## New 816 Linear Actuator Limit Adjust Caps

**PRODUCT:** Nice 816 Linear Actuator

**DATE:** 11/22/2022

**SUBJECT:** Caps covering limit adjust screws have been changed.

**FIG-1: Nice 816 Actuator Limit Switch Adjust  
Cap Location**

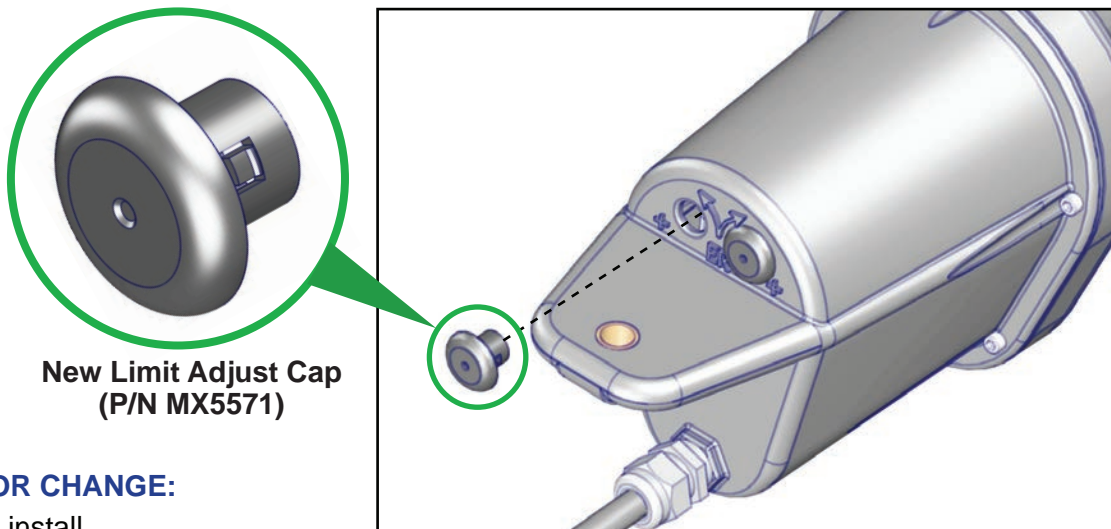
Two limit adjust screws on the rear of the 816 actuator motor housing are covered with protective caps (FIG-1). A better alternative cap (new P/N MX5571) has been sourced to replace the old screw-in cap and gasket (P/N MX71050005 and P/N 76010003).

**New Limit Adjust Cap  
(P/N MX5571)**

- Easier to install
- More durable
- Fewer components to handle

- Longer lasting plug
- No concern of losing gasket
- No chance of stripping thread
